Project Name: Pattengill - Bid Package 2 – Footings & Foundations
Project No.: 221125-190
Architect: Kingscott
Date: 4/12/24

Date: April 11, 2024
Project: Pattengill Modular Classroom Building
Owner: Lansing School District
Location: Lansing, MI
A/E #: 2616.05

ADDENDUM NO. 2

1
S1.0 FOUNDATION PLAN
Scale: 3/32" = 1'-0"

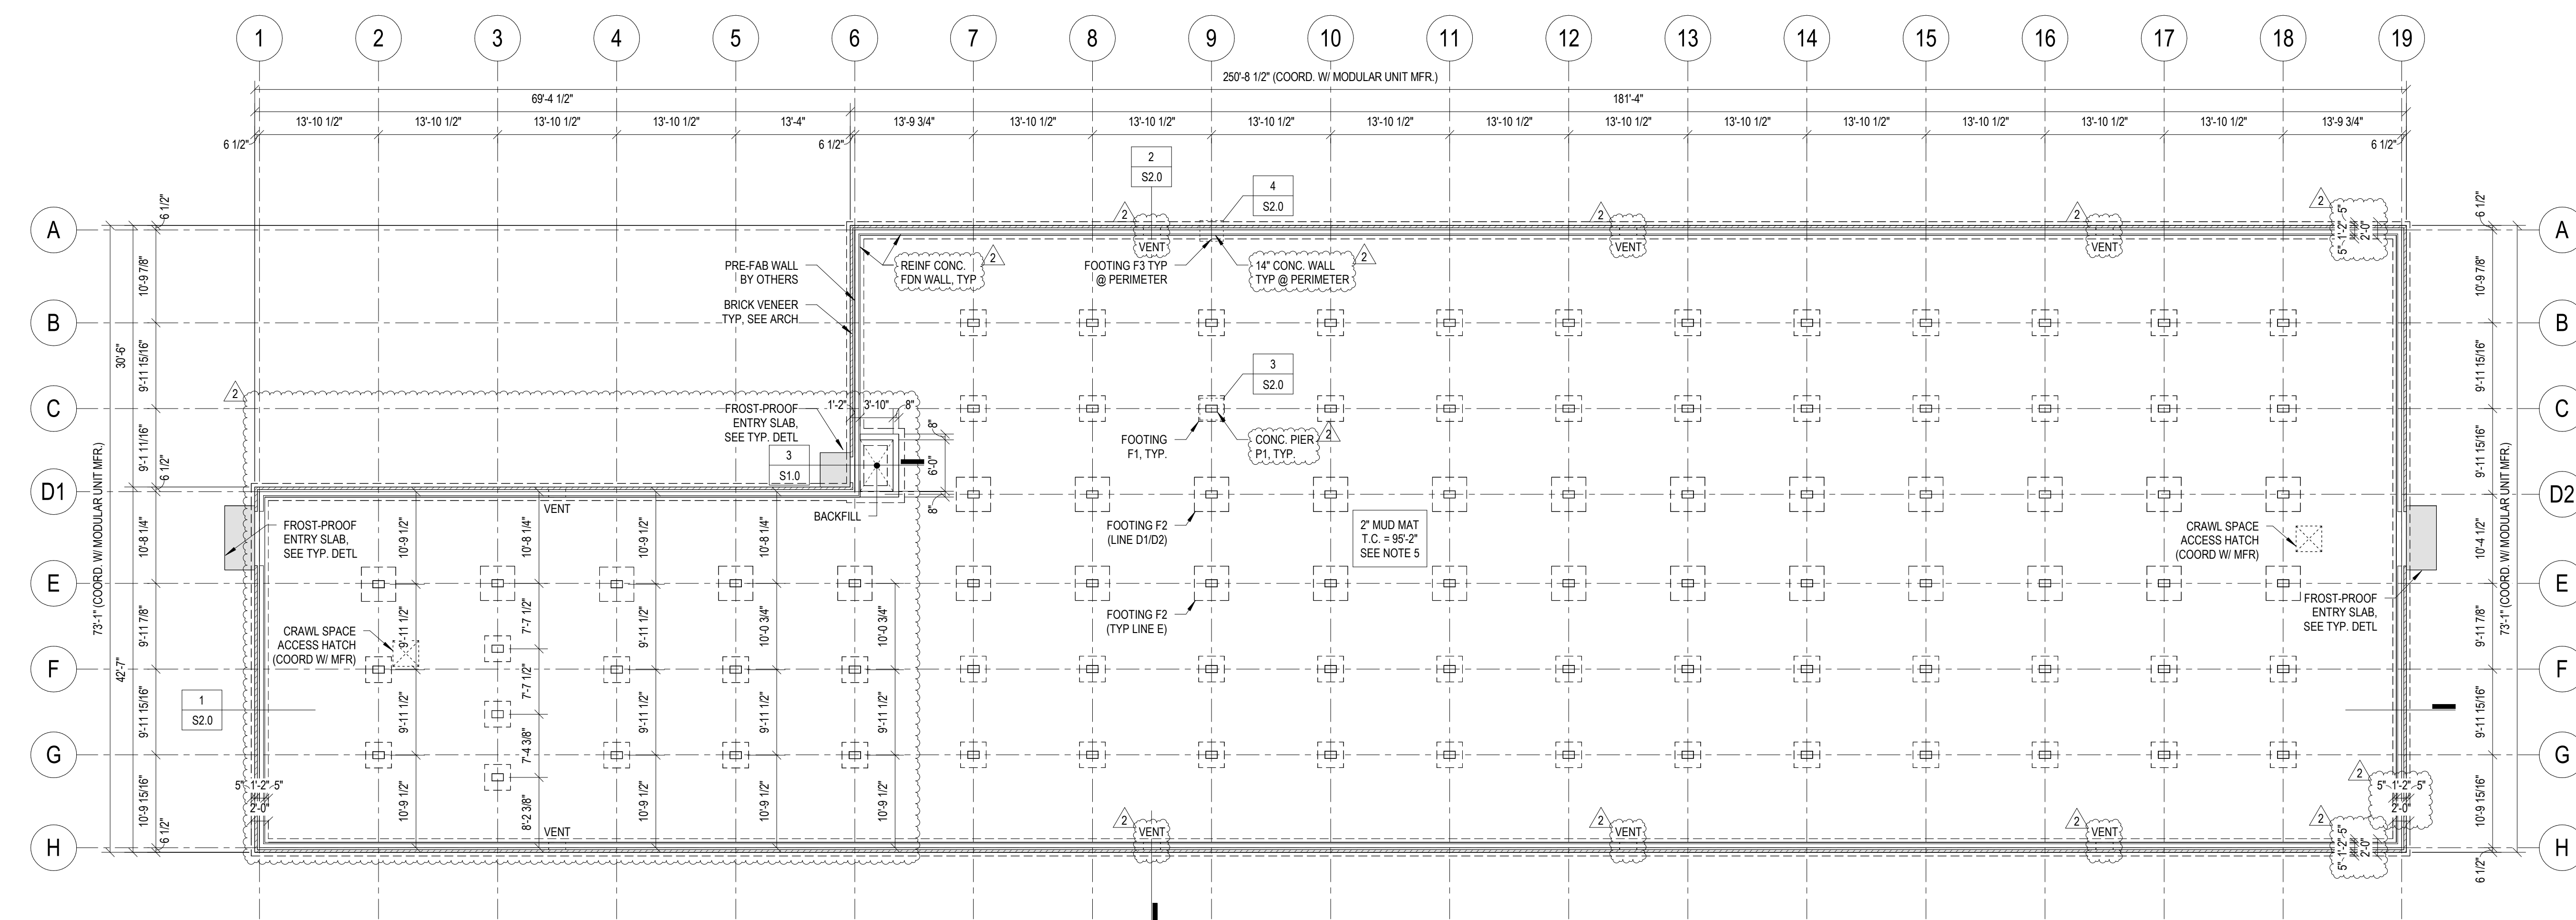
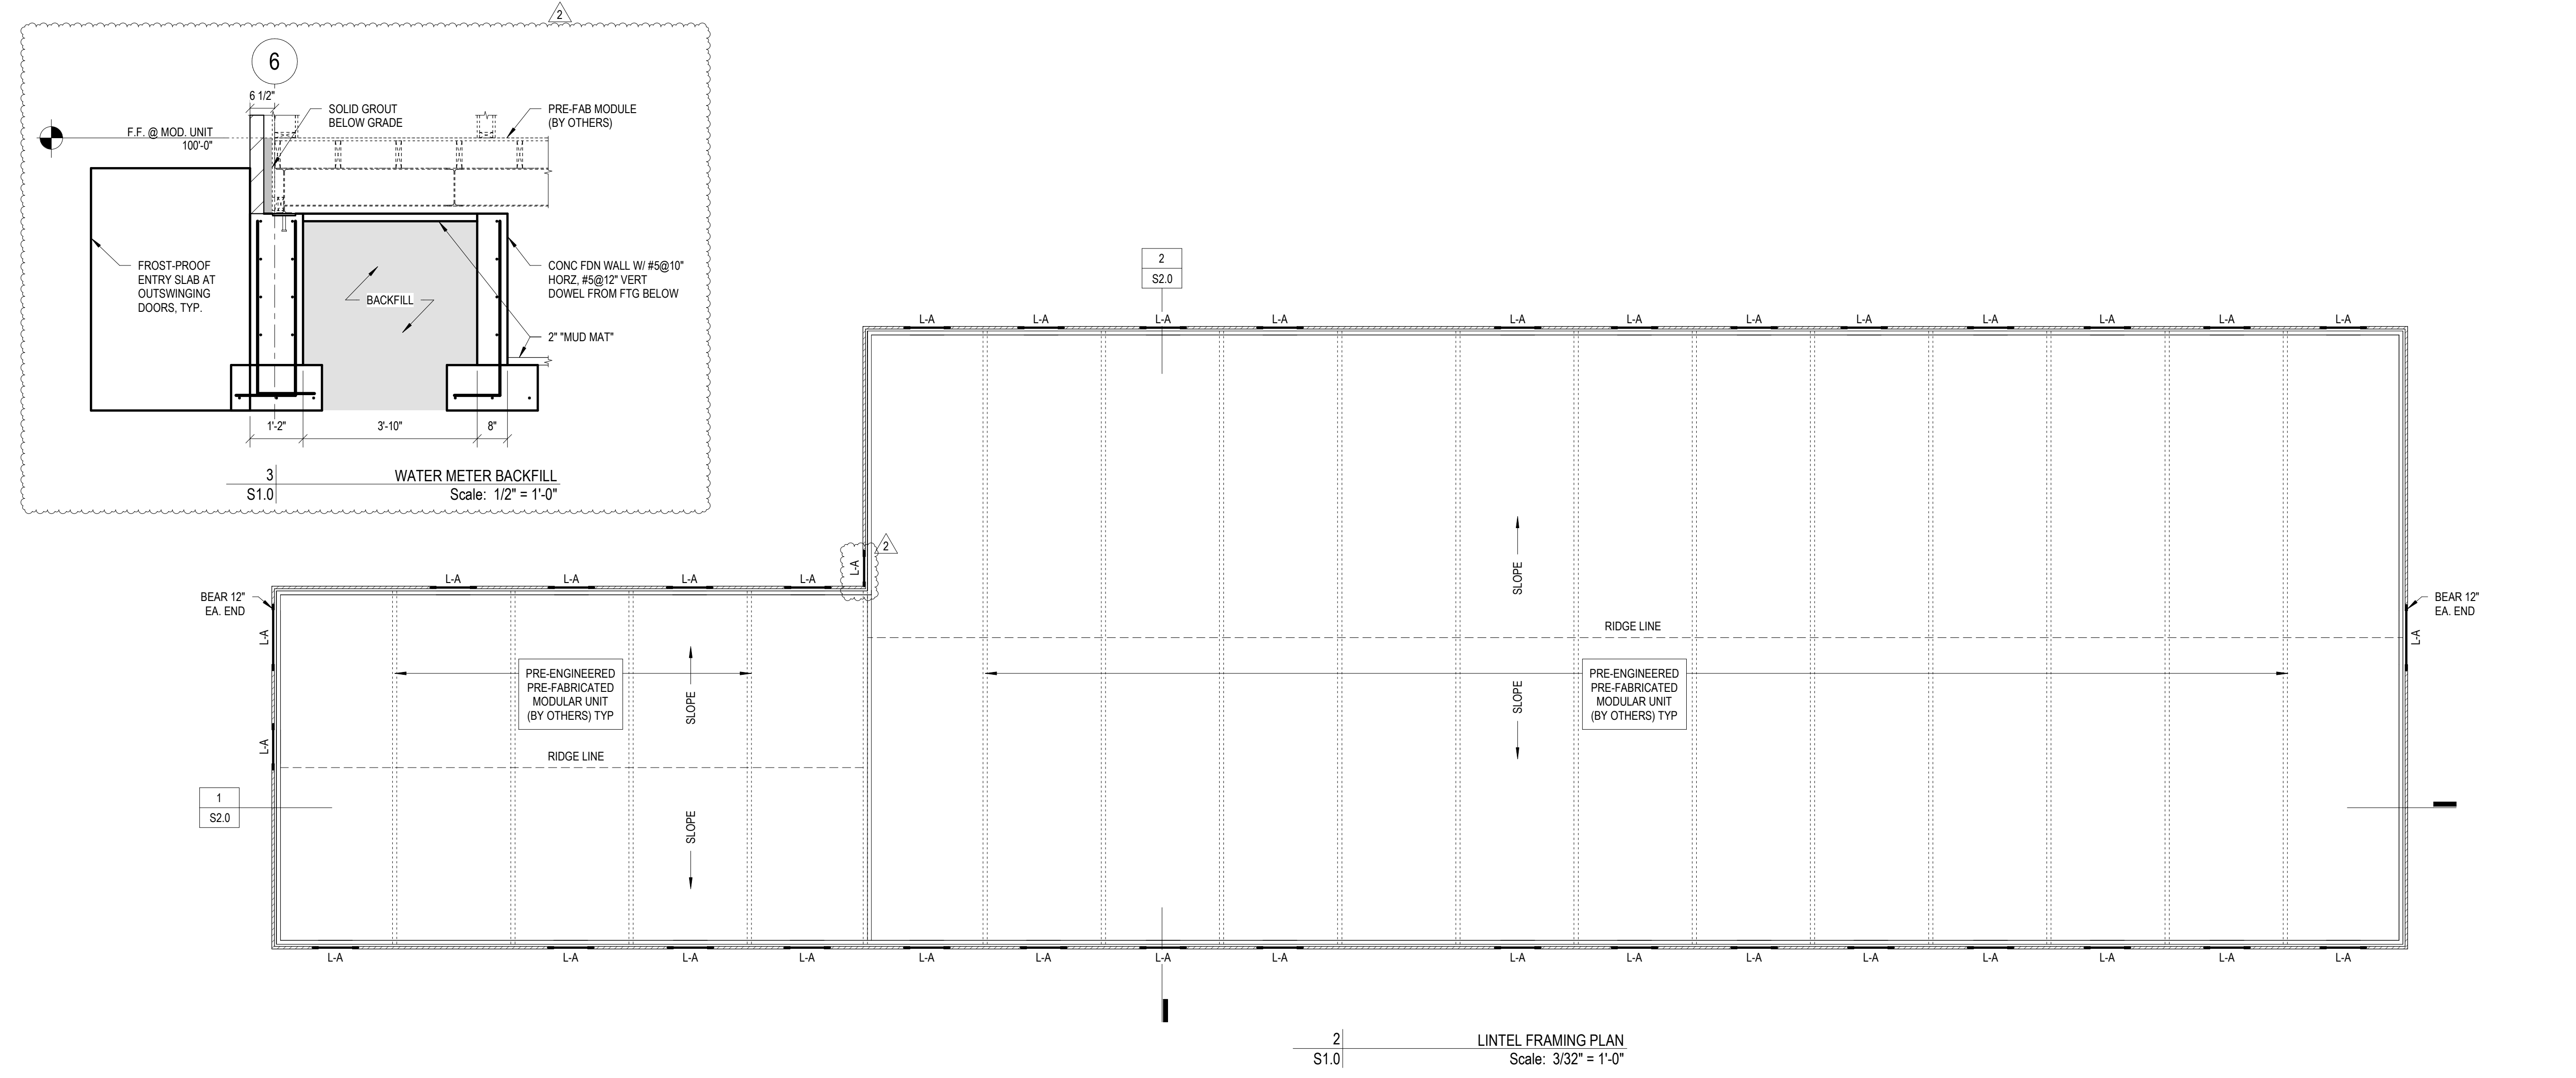
- 1/S1.0 “Foundation Plan” added disclaimer stating the pre-manufactured unit supplier has declined to provide necessary reactions and RDA waives any responsibility for pre-manufactured unit design.
- 1/S1.0 “Foundation Plan” adjust footing sizes and locations based on updated pre-manufactured unit plans provided. Also changed from reinforced CMU foundations to reinforced concrete foundations and added a portion of backfilled area within the crawl space below water meter room (Detail 3/S1.0).

1 BUILDING SECTION (LOOKING EAST)
Scale: 1/4" = 1'-0"

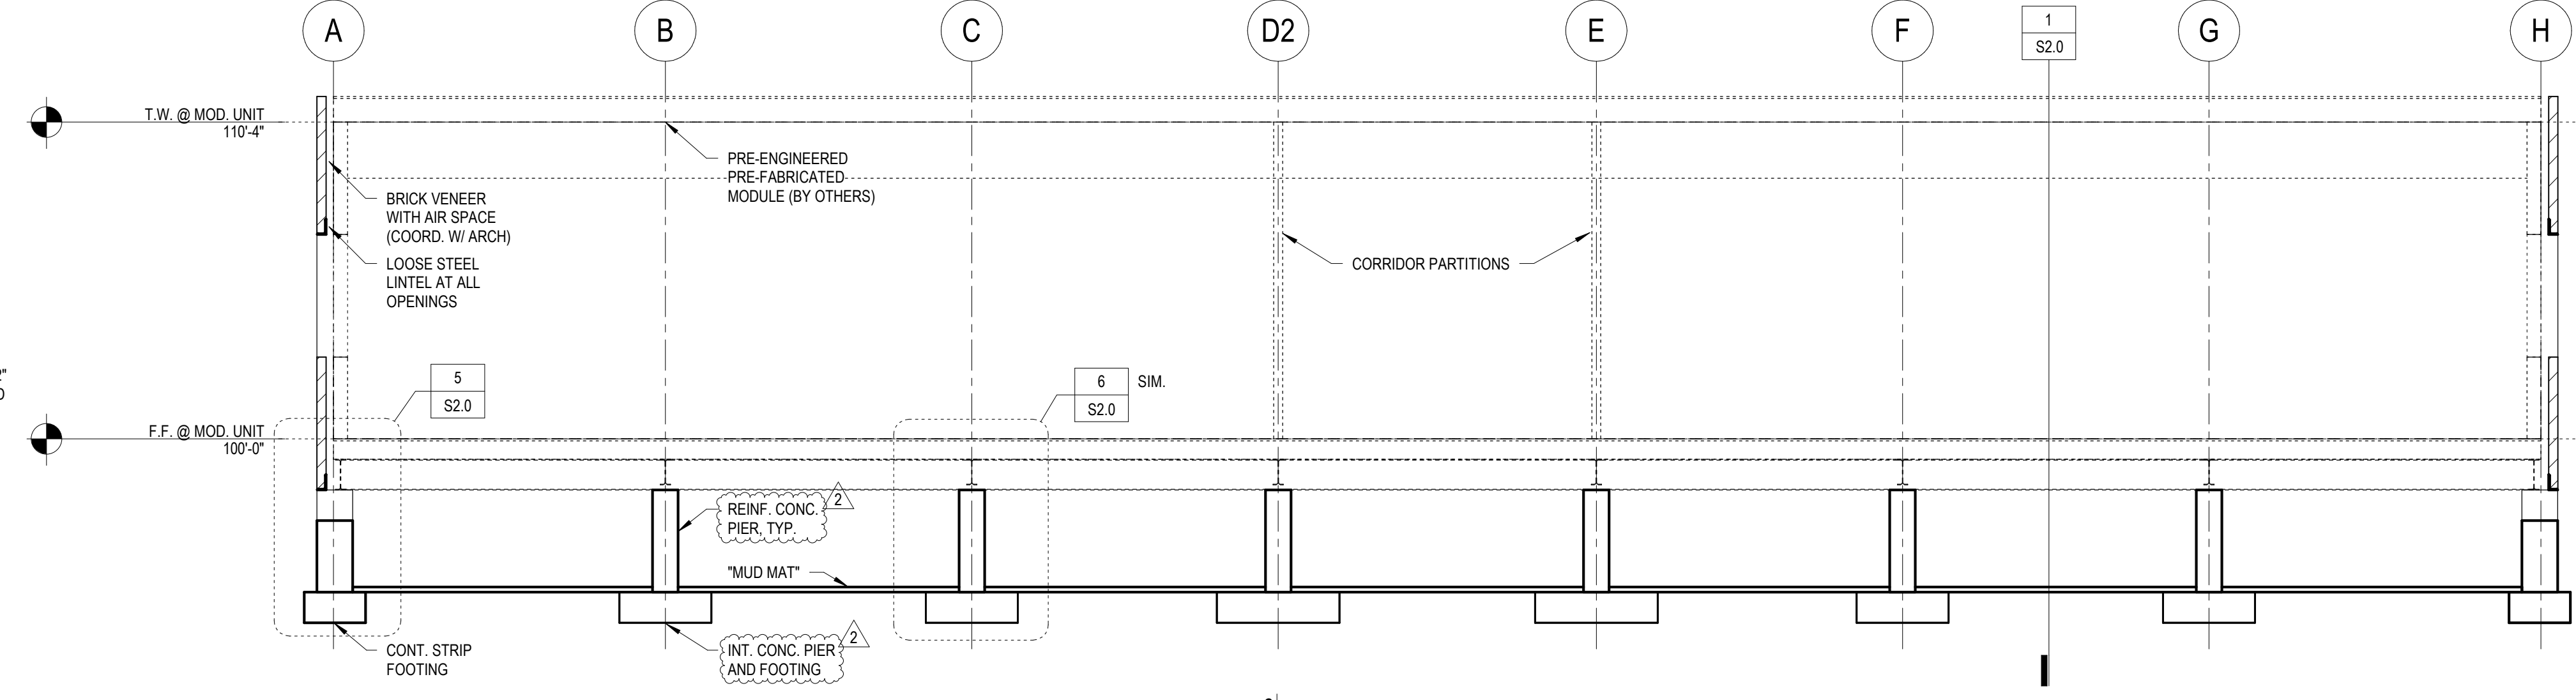
- 1/S2.0, revised section from reinforced CMU foundations to reinforced concrete foundations.
- 2/S2.0, revised section from reinforced CMU foundations to reinforced concrete foundations.
- 3/S2.0, revised detail from reinforced CMU to reinforced concrete.
- 4/S2.0, revised detail from reinforced CMU to reinforced concrete.
- 5/S2.0, revised detail from reinforced CMU to reinforced concrete, and added ventilation louvers.
- 6/S2.0, revised detail from reinforced CMU to reinforced concrete.
- 13,14,15/S2.0, removed typical CMU details and provided additional typical concrete details.
